ADDRESS: 1760 VAN DYKE

APPLICATION NO: #22-8157

HISTORIC DISTRICT: WEST VILLAGE

SCOPE: REPLACE WOOD WINDOWS WITH NEW VINYL WINDOWS

The following are photos of the five windows proposed for replacement (provided by applicant):

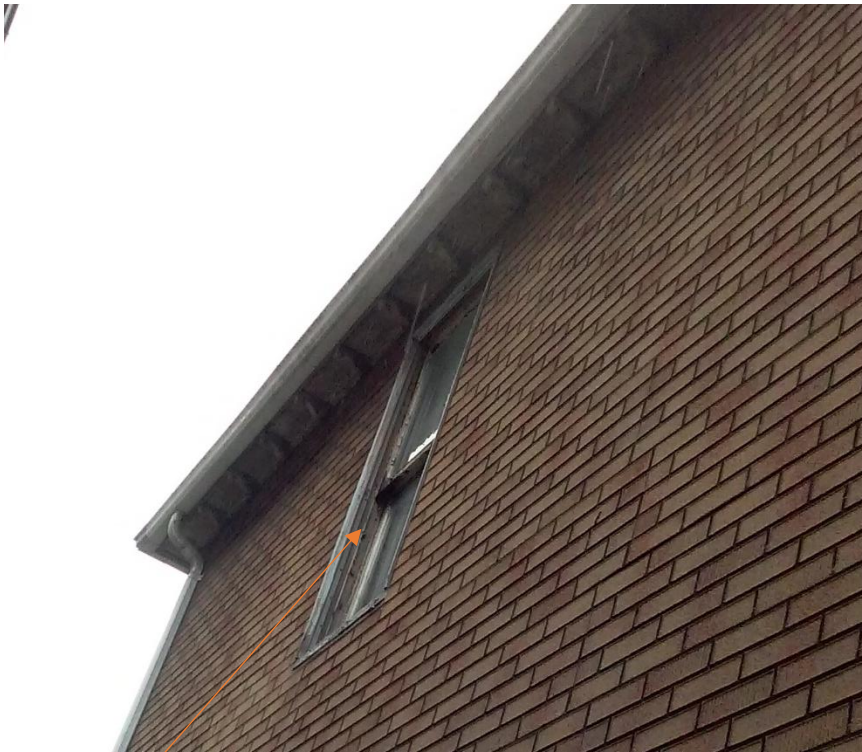
proposed for replacement include the set of paired 1/1 wood windows at the front elevation second story, a single 1/1 wood window at the side north elevation second story, and two 1/1 wood windows at the rear elevation. See the below photos of the windows proposed for replacement. The applicant has stated that the windows proposed for replacement are “too old to be repaired.”

- The five wood windows and associated trim proposed for replacement are distinctive character defining features at the home and it appears that they are not deteriorated beyond repair. As the home is clad with asphalt shingles and several wood windows have been replaced with vinyl units, it is staff's opinion that all remaining historic-age features (to include the five windows proposed for replacement) should be retained or replaced in kind when necessary in order to forestall any further diminution of the home's historic character.

HDC staff recommends that the Commission issue a Denial for the proposed project because the work does not conform to the district's Elements of Design and does not meet the Secretary of the Interior's Standards, in particular Standards #:

- 2.) *The historic character of a property shall be retained and preserved. The removal of historic materials or alteration of features and spaces that characterize a property shall be avoided.*
- 5.) *Distinctive features, finishes, and construction techniques or examples of craftsmanship that characterize a property shall be preserved.*
- 6.) *Deteriorated historic features shall be repaired rather than replaced. Where the severity of deterioration requires replacement of a distinctive feature, the new feature shall match the old in design, color, texture, and other visual qualities and, where possible, materials. Replacement of missing features shall be substantiated by documentary, physical, or pictorial evidence.*
